# 2.0 Phase 2 integration with Phase 1

# APPENDIX A PART 2 OF 3

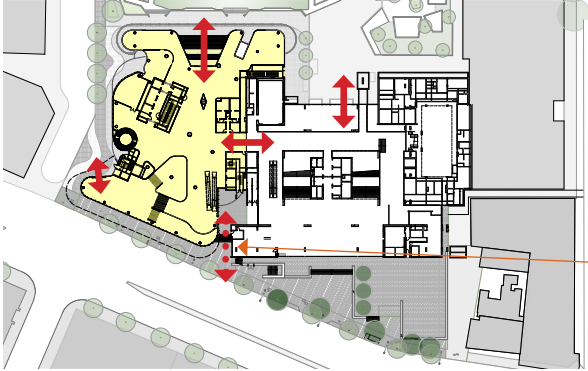
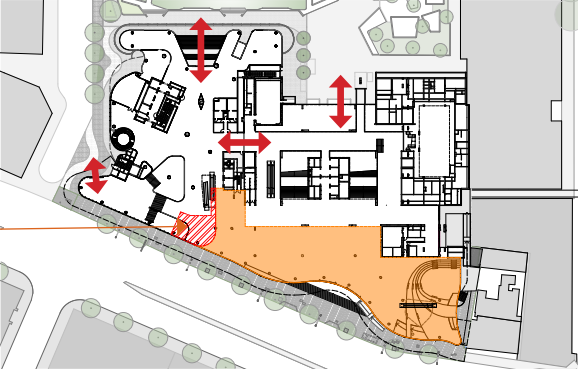
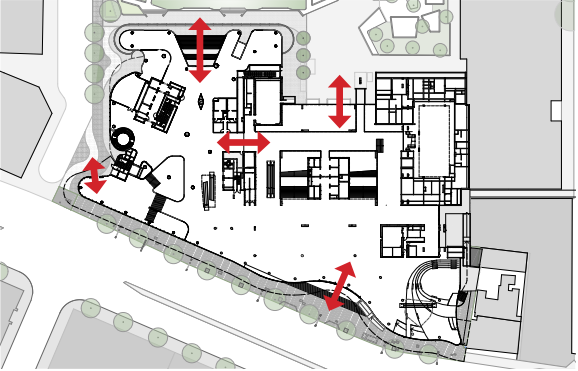
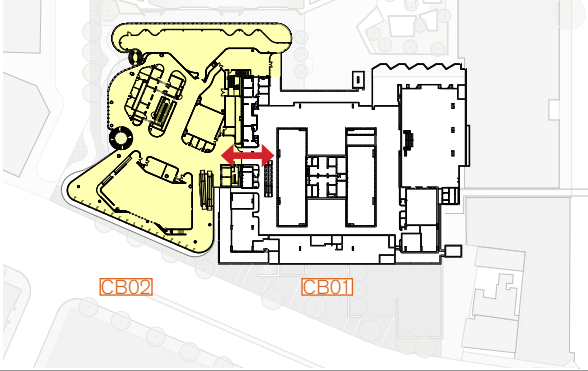
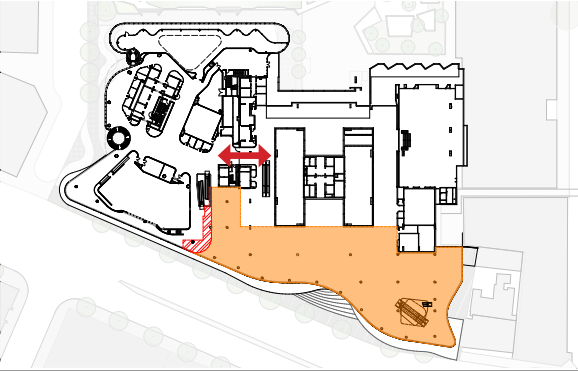
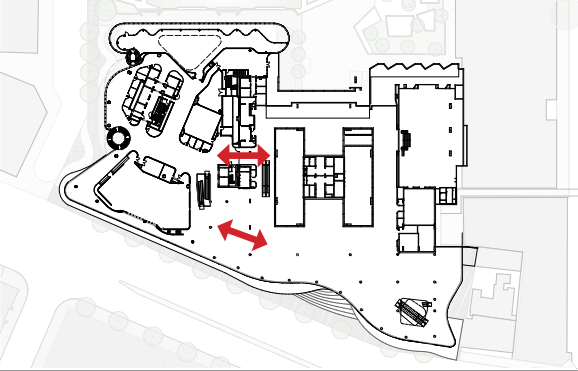
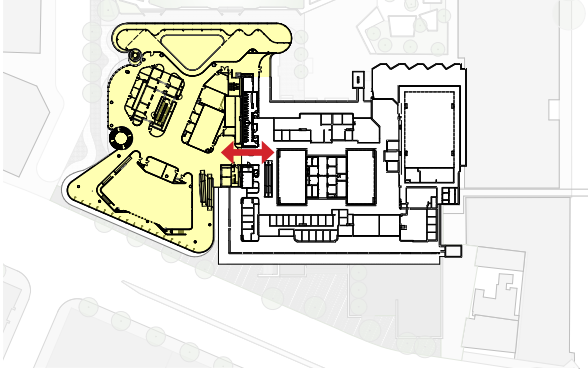
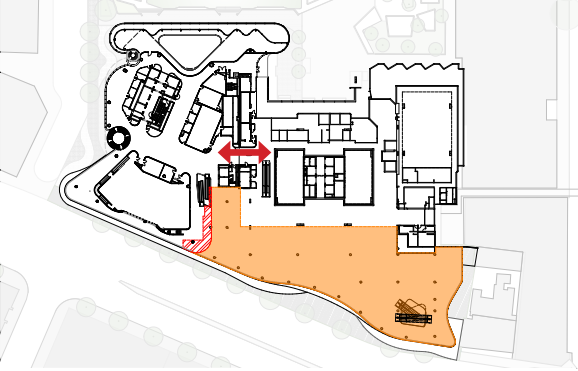
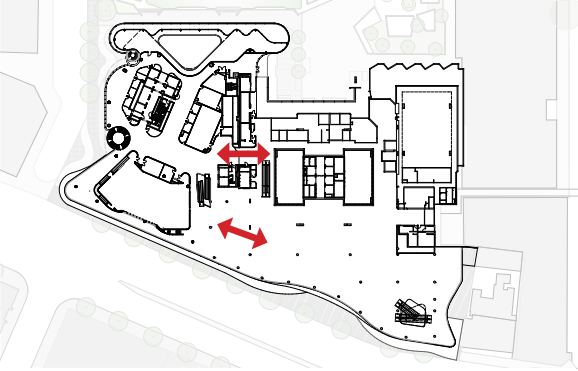
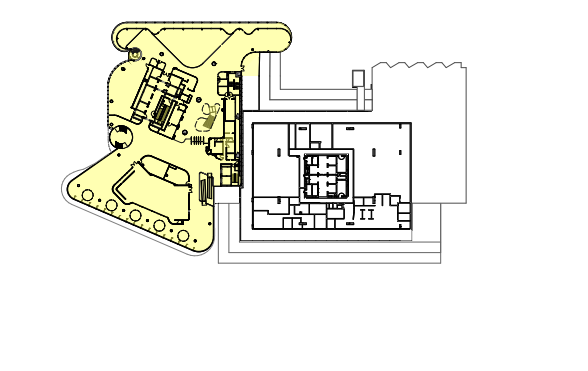
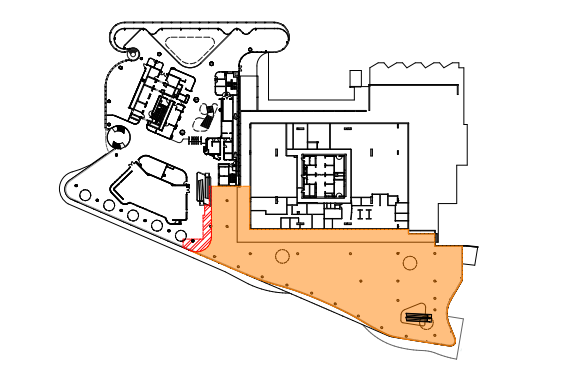
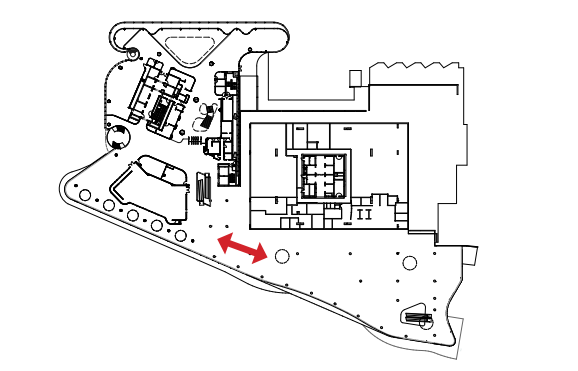
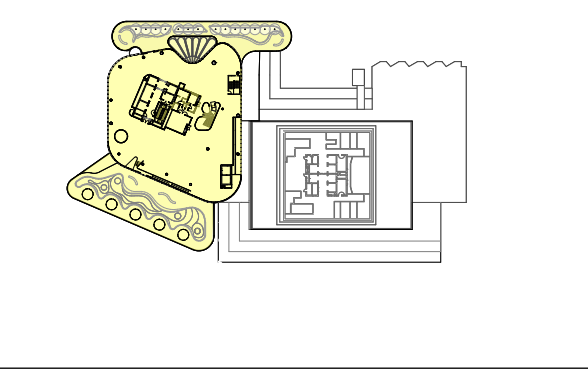
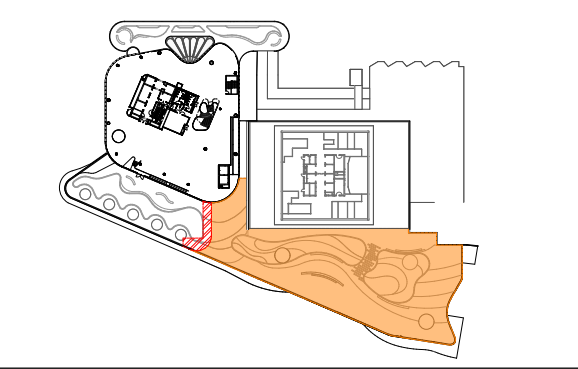
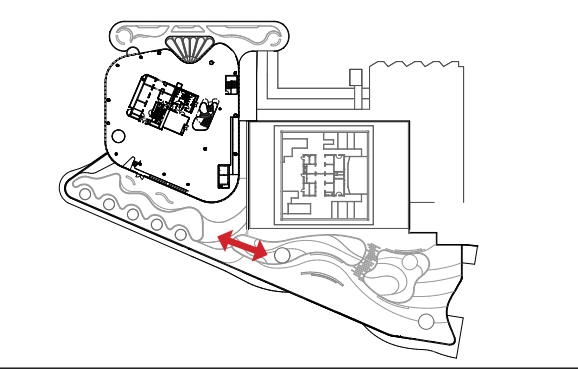
The documents supporting the staging proposal must demonstrate how the Phase 2 work would integrate with the Phase 1 work, including plans and a program of works, as the Phase 2 works would require removal of large sections of the façade and integration with curved floor plates.

Refer to Appendix C for statement on integration of Phase 2 works with Phase 1 prepared by Richard Crookes Constructions.

The following section includes staging plans demonstrating the stitching point between Phase 1 and Phase 2, in addition to showing in plan which areas of Phase 1 will be impacted by the construction of Phase 2. The diagrams confirm that façades to the perimeter of existing building CB01 and a small area of Phase 1 (CB02) will need to be demolished where abutting the construction zone.

The staging plans further demonstrate the integration of the Phase 1 floor plates upon construction of Phase 2, allowing for a seamless interface upon completion of Phase 2.

Level 5 - Original DA location of General Teaching Space

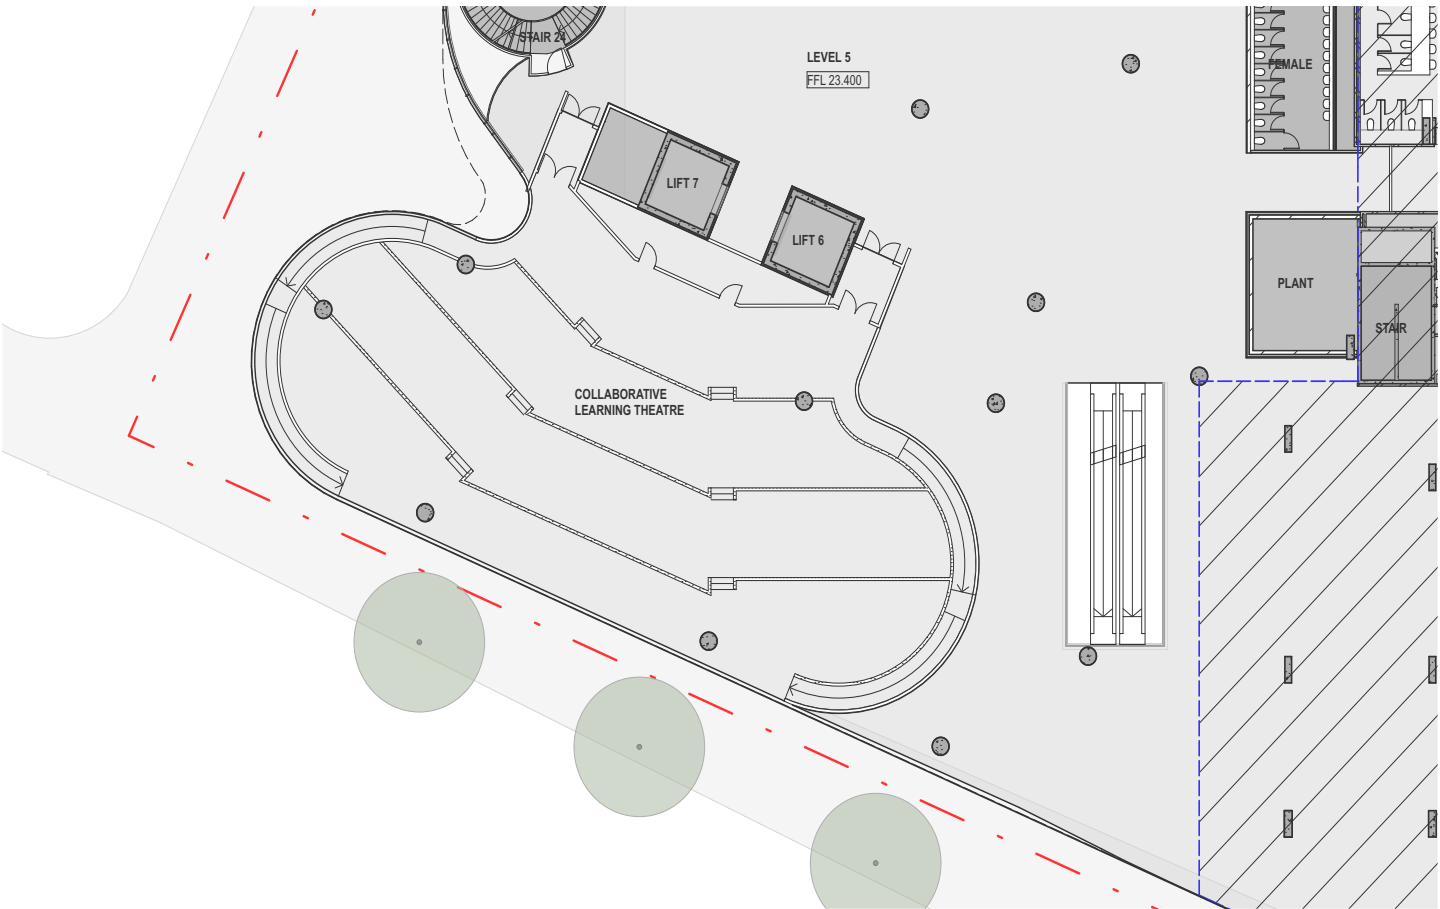
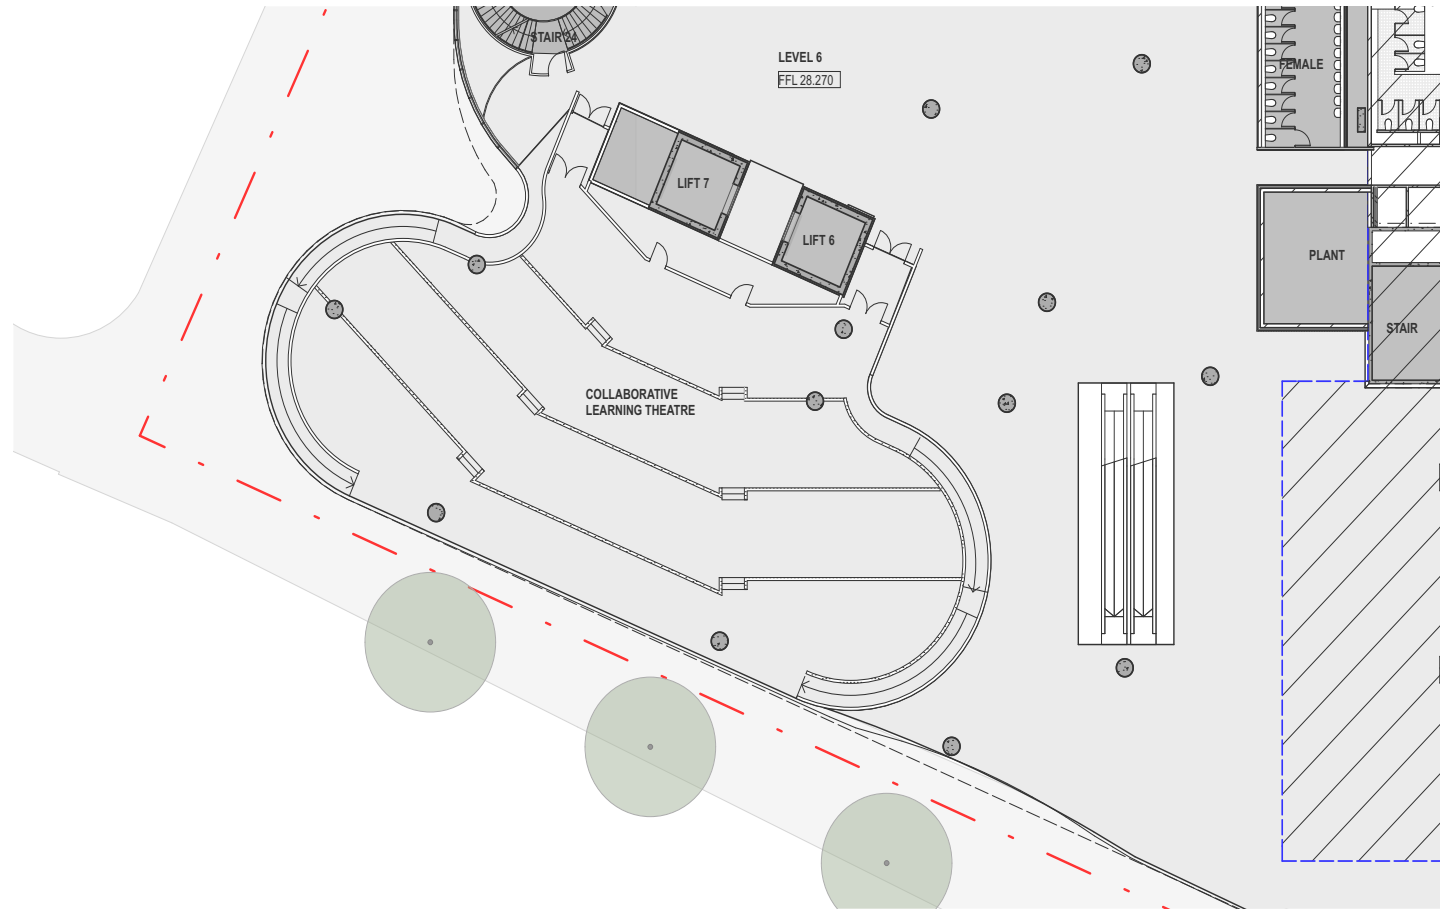
Clarification should be provided in relation to conflicting information regarding the Collaborative Learning Theatre, which appears to have been replaced by three single storey General Teaching Spaces. Further justification and detail is required to support this modification, including ceiling heights, program, entry and circulation and capacity.

In the DA three collaborative teaching spaces were shown on levels 5, 6 and 7. These spaces have been retained in the Section 96 submission. The only change that has occurred is the shape of these spaces as a result of adjusting their position to be more central on the floor plate and away from the facades on Broadway and Jones Street. The spaces shown in the Section 96 retain the same proposed ceiling heights, programme, circulation and capacity.

The terms Collaborative Learning Theatre and General Teaching Spaces reference the same spaces, and both can be used to describe the use of these spaces.

The adjusted location of each of the GTS provides a much improved relationship with the Broadway facade allowing informal learning spaces to be located between the GTS and the facade.
